AMENDMENT OF SOLICITATION/MODIFICATION OF CONTRACT

1. The specifications and drawings for Invitation No. DACW64-03-B-0010, Dredging, Mile 293 to High Island in Jefferson, Chambers, and Galveston Counties, Texas, Gulf Intracoastal Waterway, Texas, advertised 14 March 2003, and for which bids are scheduled to be opened on 15 April 2003, are hereby modified as follows:

(To Accompany Amendment No. 0001 to Invitation No. DACW64-03-B-0010)

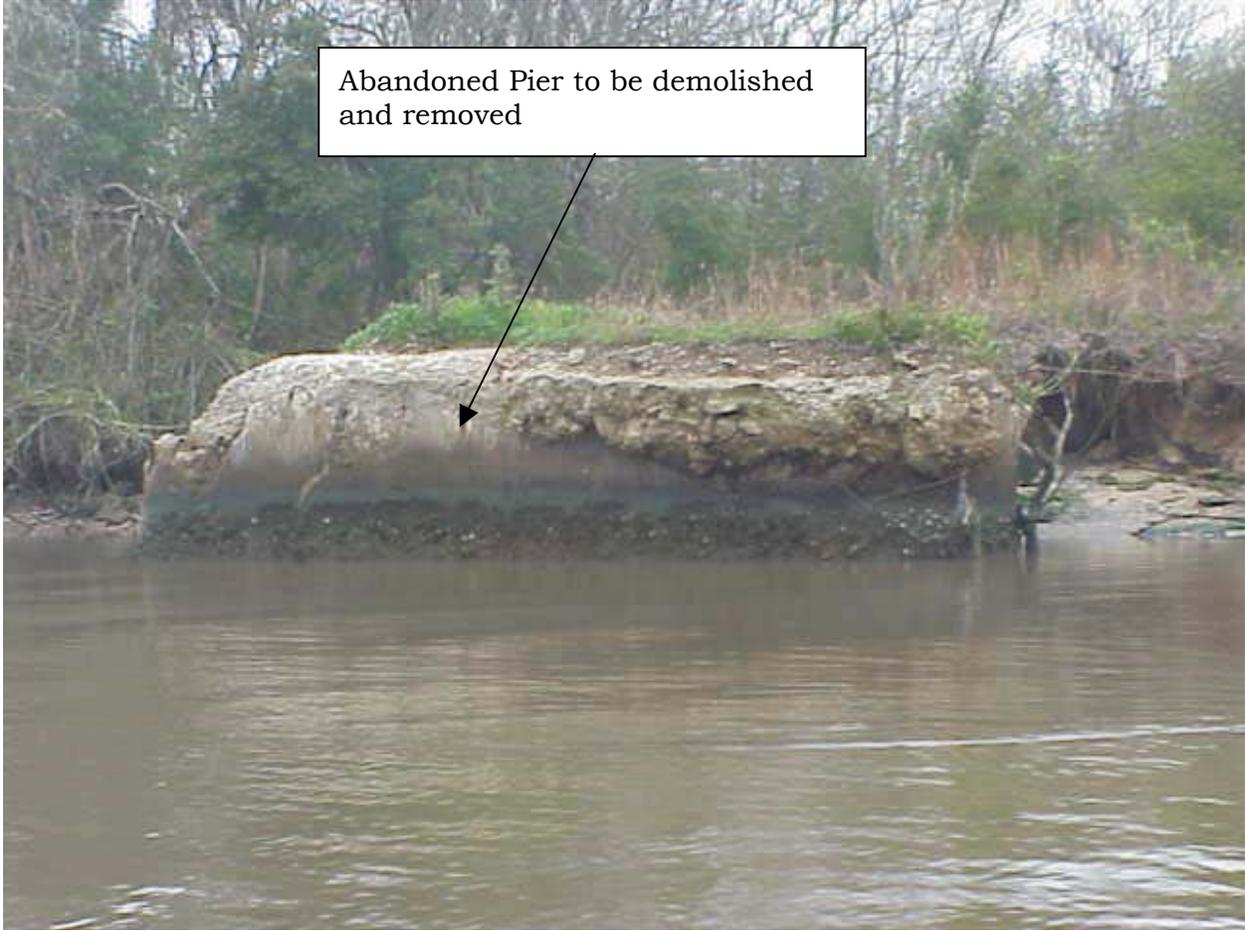
3.1 REMOVAL OF EXISTING ABANDONED BRIDGE PIER STRUCTURES. Formed in place steel reinforced concrete bridge piers shall be demolished and removed from the existing navigation channel by utilizing a boom-mounted pneumatic breaker and air powered saw to minimize impact to the surrounding environment. Treated wooden pilings shall be removed with a minimum amount of damage to the piling. The Contractor shall coordinate demolition efforts with the local Drainage District at (409) 842-1818 for the removal of existing guy wire and electrical conduit fastened to the downstream abandoned bridge pier structure.

3.1.3 Removal. The contractor shall demolish and remove material in sections. No part of the structure will be allowed to fall into the water. Components that have been dropped into the water shall be removed from the water before demolition can proceed. The Contractor shall remove existing engineered materials and debris within a 25-foot radius measured horizontally from the structure perimeter that has resulted from the gradual deterioration of the structure. The Contractor shall demolish and remove existing engineered materials and debris to a depth of 3 feet measured from the existing mud line.

Conduit to be removed prior to demolition

Abandoned Pier to be demolished and removed

Footing to be demolished and removed

Demolition of Downstream Piers
